BEREWOOD : PHASE 2

Design and Access Statement - Addendum

Rev C - 06 May 2014

Revised Site Layout April 2014

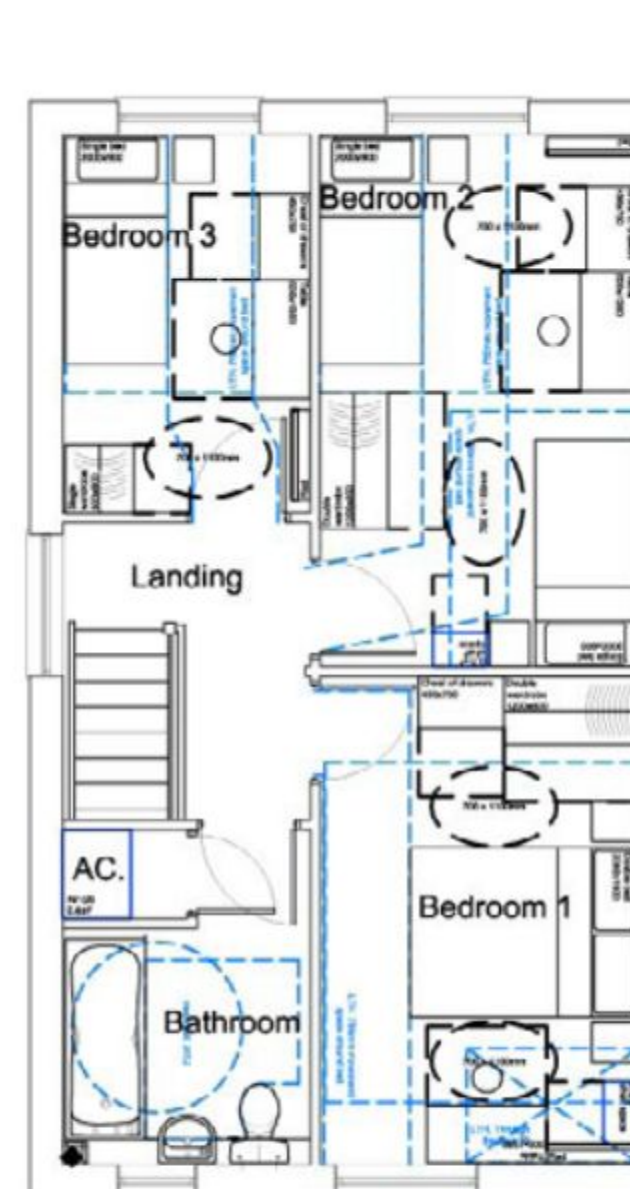
Revised Proposals

The bin collection points have been keyed with material surface treatments on the hard surfaces layout.

The parking in front of plots 93-96 has been reconfigured to provide parking better related to the properties, allow for additional landscaped areas and reduce the amount of hard surfaced.

The turning head between plots 133 & 134 has been redesigned to reduce the amount of hard surface and allow for additional landscaped area to soften this space.

Architectural Detailing - Flat Block A Elevation Facing Public Green

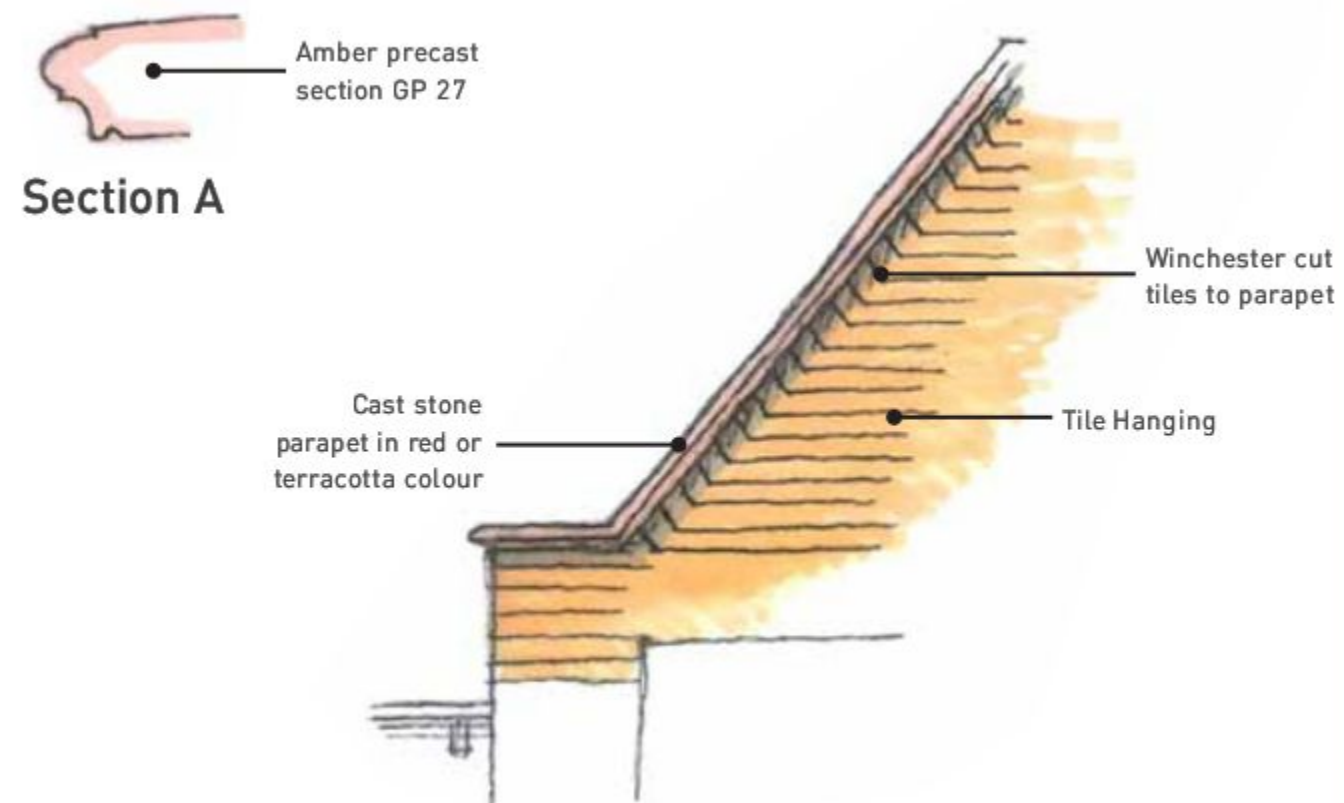
Comments on the elevational appearance of Flat Block A related to the lack of attention to detail in the cad drawings when contrasted with the handdrawn version. Rather than add extraneous features our approach has been to examine the elevation and enhance the architectural detail of main elements which are;

- The pair of rendered towers at each end of the elevation and
- The central tile hung gable.

Sketches and coloured diagrams show where the original elevation has been amended and the details that are to be enhanced.

Detail 4: Wall and Base (1:5)

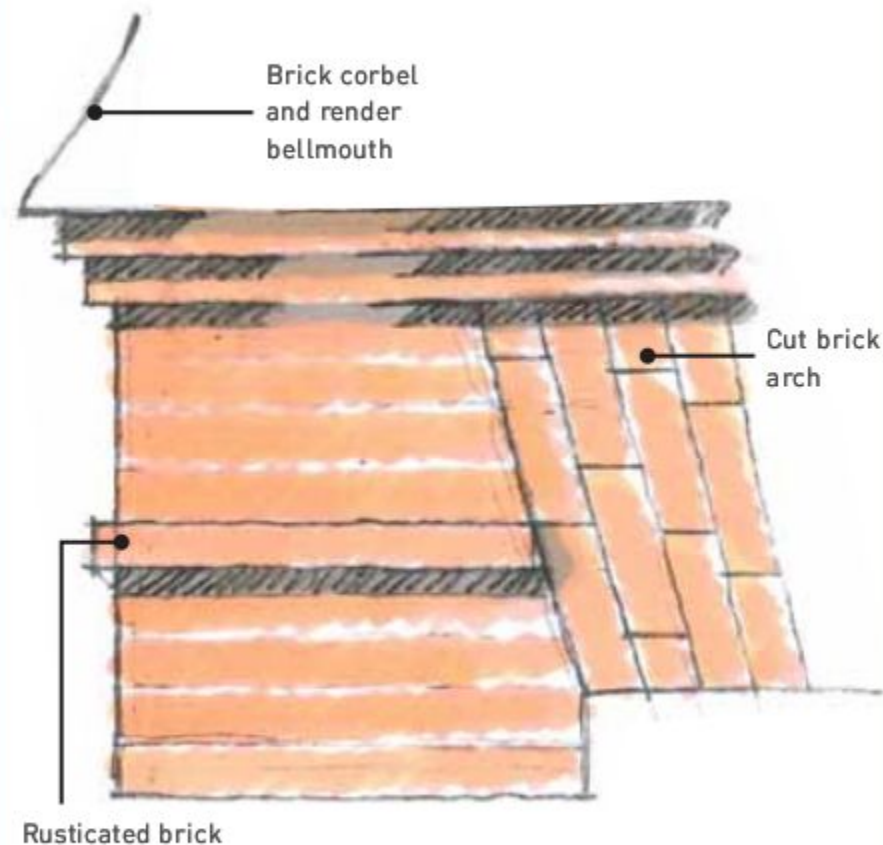
The brick base to the feature tower will be enhanced using a double skin of brick work. This will allow a central recess of 100mm to be created between the brick rusticated piers

Vehicle tracking to courtyard Flats E

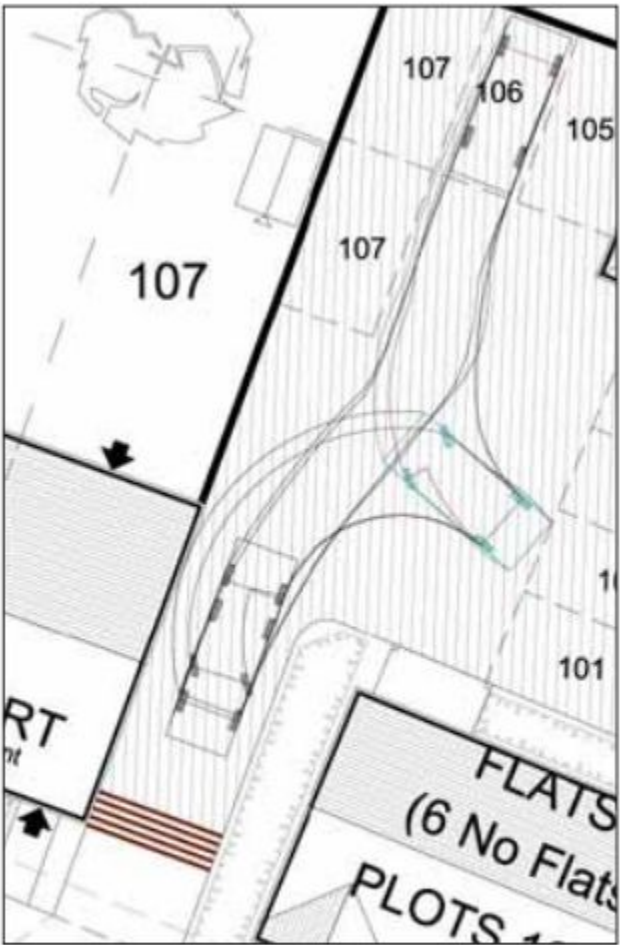
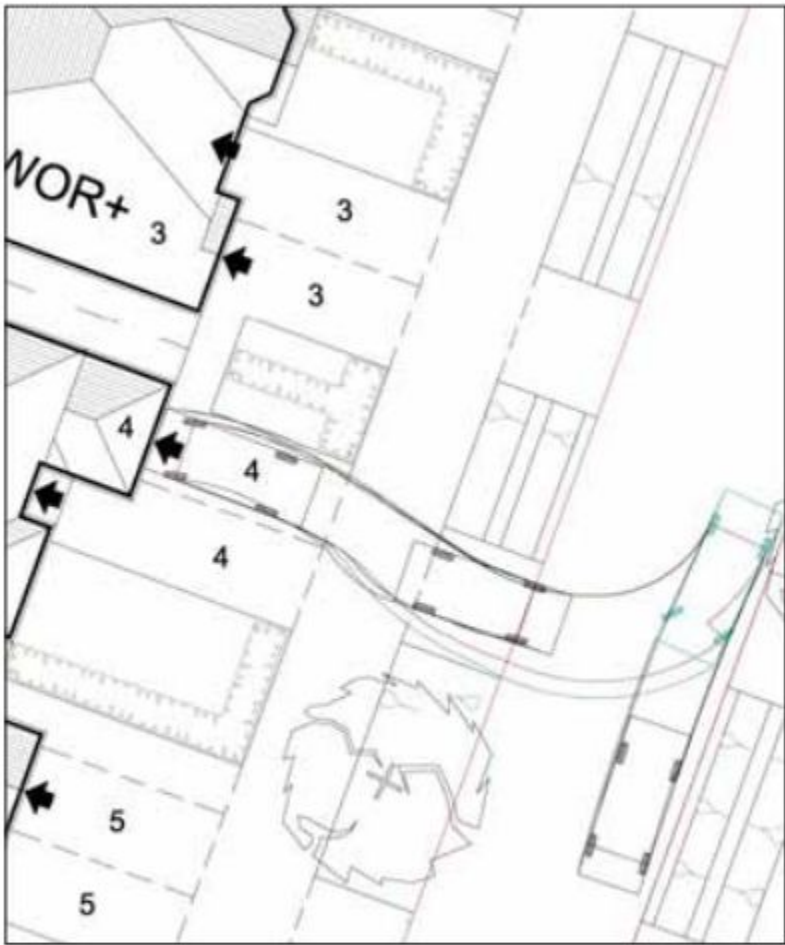
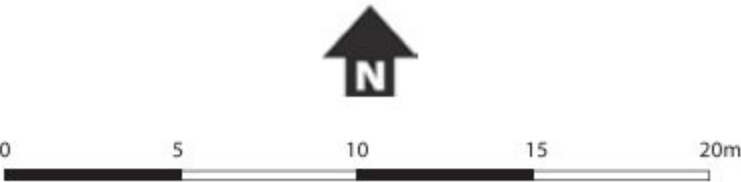
Several of the tighter parking courtyards and the revised design for the cross over to the swale have been tested for vehicle tracking. An extract of the track plots is shown on the accompanying plans.
